1335 Swindon NEV, Old Vicarage Lane

Road Safety Audit Stage 1/2 – Designers Response
8th September 2022

STAGE 2 ROAD SAFETY AUDIT

Proposed Section 278 Works at Old Vicarage Lane, South Marston, Swindon on Behalf of the Swindon EDA Consortium

Audit Reference Plan

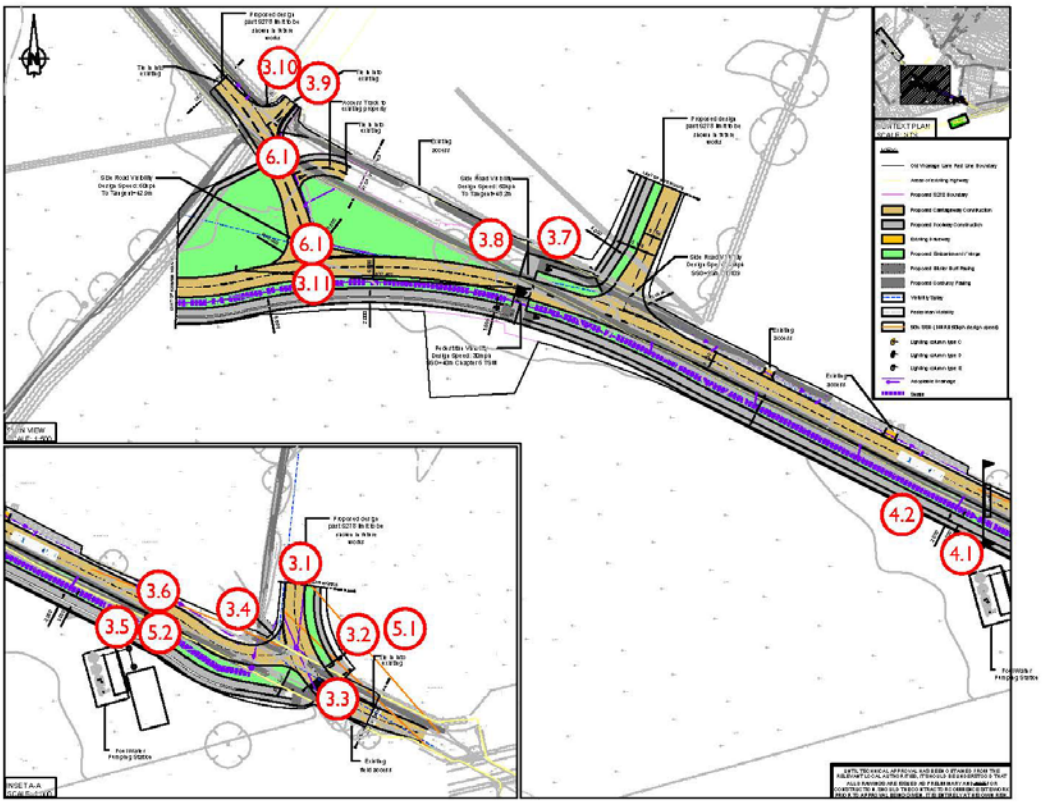
3.1 Location: Proposed junction west of railway bridge

Old Vicarage Lane is currently subject to the national speed limit (60mph) along the length subject to this audit and up to the junction with the A420. It would appear from the signage drawing provided to the Audit Team that the intention is to extend the 30mph speed limit east to a point immediately east of The Carpenter's Arms public house. The assumption is that the section of proposed re-aligned road from a point shown on the drawing to the immediate west of the rail bridge, that travels west and then turns north, will remain subject to the national speed limit. The curvature of the realigned road would appear to be too tight for vehicles to safely negotiate at this higher speed. Vehicles may lose control should they attempt to drive at or near the posted speed limit.

3.1.1 Re-design the highway alignment to suit the existing speed limit (i.e. 60mph); or change the speed limit of this section of road to suit the necessary design parameters.

3.2 Location: Proposed footway / shared route junction, east end of scheme

At the eastern end of the proposed scheme, on the northern side of the carriageway, there appears to be a proposed footway joining a proposed shared use footpath / cyclepath. No corduroy paving appears to be shown on the drawings provided to the Audit Team to warn visually impaired pedestrians of the change of use.

3.2.1 Install corduroy paving at this location.

3.3 Location: Proposed segregated footway / cycleway route crossing point, east end of scheme

At the eastern end of the proposed scheme, the proposed segregated footway / cycleway crosses Old Vicarage Lane by means of an informal crossing point, the alignment of such would appear to be an in-line arrangement. A visually impaired person walking at speed may not pick up the tactile paving arrangement as detailed as it does not extend across the full width of the

3.3.1 Provide tactile paving across the full width of the crossing point and to a depth of 1,200mm.

3.4 Location: The Carpenter's Arms public house, vehicular access

The frontage / access to The Carpenter's Arms public house has not been shown on the plans provided to the Audit Team. It is unclear whether there is suitable separation between the entry to the public house frontage / car park and the proposed junction to ensure adequate intervisibility is available for all approaching drivers at this location, particularly at the eastern end of the public house frontage, adjacent to a hedge.

3.4.1 Ensure adequate intervisibility is available for all approaching drivers at this location.

3.5 Location: Proposed segregated footway / cycleway route, (assumed) crossing point to The Carpenter's Arms public house

There is a spur shown from the proposed segregated footway / cycleway route in the approximate location of The Carpenter's Arms public house. It is assumed by the Audit Team that this is to be a crossing to the public house. Given the width shown on the plans, it is also assumed to be a pedestrian link and not a shared one. On crossing from the public house to gain access to the proposed segregated footway / cycleway route, this pedestrian link will join on the cycle side of the segregated route. Visually impaired pedestrians may enter into the cycleway into the path of an oncoming cyclist unaware of the designer's intention at this location.

3.5.1 Provide corduroy paving at the junction of the footpath link and the proposed segregated footway / cycleway route. A route across the cycleway should also be provided to guide pedestrians to the footway side of the segregated route.

3.7 Location: Proposed segregated footway / cycleway route, west of proposed new junction

A proposed segregated footway / cycleway route has been shown on the northern side of Old Vicarage Lane, immediately to the west of the proposed side road. The road markings and tactile paving shown on entry to this segregated route when crossing from the southern side of Old Vicarage Lane contradict each other; the transverse tactile paving is shown on the same lane as the cycle symbol.

3.7.1 Provide matching tactile paving and road markings at all required locations.

3.8 Location: Severed section of Old Vicarage Lane

It is proposed to sever a section of Old Vicarage Lane, between the proposed side road and Rowborough Lane. A priority junction is to be provided to allow vehicular access to this length of road to retain access to an existing property at this location. There is also a proposed segregated footway / cycleway route shown immediately to the west of the proposed side road. The segregated footway / cycleway route would appear to run into the length of severed section of Old Vicarage Lane. There does not appear to be any segregation between the segregated footway / cycleway route and the length of severed section of Old Vicarage Lane to prevent motor vehicle entry to the footway / cycleway facility.

3.8.1 Provide measures to prevent motor vehicle access to the footway / cycleway at this location.

3.9 Location: Rowborough Lane

It is proposed to re-align the junction of Old Vicarage Lane and Rowborough Lane. The drawings provided to the Audit Team indicate the provision of a footway on the eastern side of the re-aligned junction. There is currently no pedestrian provision along Rowborough Lane for this proposed footway to connect to. Pedestrians that use this footway will need to enter the main carriageway to continue north-east. Visually impaired pedestrians may not be aware of the change in usage.

3.9.1 If the intention is to transition pedestrians into the main carriageway, corduroy warning paving should be provided at the transition between footway and carriageway to warn visually impaired pedestrians of the change of usage.

3.10 Location: Rowborough Lane

It is proposed to re-align the junction of Old Vicarage Lane and Rowborough Lane. The drawing provided to the Audit Team indicates that the width of highway at this location will be 4-4.5m. Rowborough Lane currently leads to light engineering premises a short distance to the north-east of this location. No swept path analysis has been supplied to the Audit Team to demonstrate the manoeuvres of the vehicle types likely to use this junction in connection with the nearby businesses. It is unclear whether mid-to-large vehicles could safely manoeuvre through this junction without encroaching into oncoming traffic or the proposed adjacent footway.

3.10.1 Undertake swept path analysis of this proposed junction re-alignment to ensure all likely vehicles types can manoeuvre safely and efficiently through it.

3.11 Location: Re-aligned Old Vicarage Lane

It is proposed to re-align Old Vicarage Lane, introducing a new priority junction at a point south of Rowborough Lane. There does not appear to be provision for cyclists travelling east or west along the proposed segregated footway / cycleway to gain entry to the section of Old Vicarage Lane that will remain to travel on to the existing village. Cyclists wishing to travel this route may attempt to cross the swale and full height kerbs, which may result in loss of control injuries.

3.11.1 Provide a link between the proposed segregated footway / cycleway and the north-west section of Old Vicarage Lane on the cyclists' desire line.

4.2 Location: Lighting column proposed adjacent to Tree T56(B)

Street lighting and landscaping plans have been provided to the Audit Team as part of this audit There would appear to be a proposed lighting column within the canopy of Tree T56(B). This tree canopy will obstruct the lighting column resulting in reduced levels of lighting during the hours of darkness.

4.2.1 Ensure proposed landscaping does not hinder the effectiveness of proposed lighting columns.

5.1 Location: Proposed footway / shared route junction, east end of scheme

At the eastern end of the proposed scheme, on the northern side of the carriageway, there appears to be a proposed footway joining a proposed shared use footpath / cyclepath. No signage appears to be shown on the drawings provided to the Audit Team to inform pedestrians of the change of use.

5.1.1 Install signage at this location.

5.2 Location: Proposed segregated footway / cycleway route, (assumed) crossing point to The Carpenter's Arms public house

There is a spur shown from the proposed segregated footway / cycleway route in the approximate location of The Carpenter's Arms public house. It is assumed by the Audit Team that this is to be a crossing to the public house. Given the width shown on the plans, it is also assumed to be a pedestrian link and not a shared one. On crossing from the public house to gain access to the proposed segregated footway / cycleway route, this pedestrian link will join on the cycle side of the segregated route. Pedestrians, particularly visually impaired ones, may enter into the cycleway into the path of an oncoming cyclist unaware of the designer's intention at this location.

5.2.1 Provide signage at the junction of the footpath link and the proposed segregated footway / cycleway route.

3.1	Re-design the highway alignment to suit the existing speed limit (i.e., 60mph); or change the speed limit of this section of road to suit the necessary design parameters.	Road will become a 30mph road once construction has been completed. This will commence from the A420 signalised junction and continue to Thornhill roundabout.

3.2	Install corduroy paving at this location.	Corduroy paving to be shown in future works when area is designed to north-east.	
3.3	Provide tactile paving across the full width of the crossing point and to a depth of 1,200mm.	Tactile paving depth extended to 1.2m provide extra protection. Width of tactiles is shown across dropped kerb extents.

3.4	Ensure adequate intervisibility is available for all approaching drivers at this location.	Visibility splays shown for Carpenters Arms on drawing.

3.5	Provide corduroy paving at the junction of the footpath link and the proposed segregated footway / cycleway route. A route across the cycleway should also be provided to guide pedestrians to the footway side of the segregated route.	Corduroy paving added at this area in accordance with document 'Guidance on the use of tactile paving surfaces'.

3.6	Provide corduroy paving at the footpath link prior to crossing Old Vicarage Lane.	Corduroy paving added at the crossing point to the pub.	
3.7	Provide matching tactile paving and road markings at all required locations.	Tactiles have been proposed in accordance with the document 'Guidance on the Use of Tactile Paving Surfaces'.

3.8	Provide measures to prevent motor vehicle access to the footway / cycleway at this location.	Bollards have been agreed with local council and are to be shown on the drawings to prevent motor access to the footway-cycleway.

3.9	If the intention is to transition pedestrians into the main carriageway, corduroy warning paving should be provided at the transition between footway and carriageway to warn visually impaired pedestrians of the change of usage.	Area to be designed in future works and include correct provision. A footpath link will be provided for movements north through Rowborough Lane and pedestrians won't be required to enter the main carriageway.

3.10	Undertake swept path analysis of this proposed junction re-alignment to ensure all likely vehicles types can manoeuvre safely and efficiently through it.	Junction has been tracked and successful movements are shown on '1335-S278-OVL-100-106F-107F-120A-121 - Vehicle Tracking'. Existing junction radii's have also been improved with the proposed design.

3.11	Provide a link between the proposed segregated footway / cycleway and the north-west section of Old Vicarage Lane on the cyclists' desire line.	Cyclists will be encouraged to cross at the cycle crossing point just further eastwards instead of at this point. There is no proposal for a cycle path being added to the north west section so a crossing would not be encouraged. Cyclists who want to travel north west will join on the carriageway at the crossing point.

4.2	Ensure proposed landscaping does not hinder the effectiveness of proposed lighting columns.	As above.	
5.1	Install signage at this location.	Segregated cycleway and end of cycle route signs added to this location.

5.2	Provide signage at the junction of the footpath link and the proposed segregated footway / cycleway route.	Sign added in location to show end of cycle route to dia. 965. Road markings to dia. 1057 added to provide pedestrians with clear identification of cycle route. Continuous profile marking to dia 1049B also used as a separator throughout the cycle route.
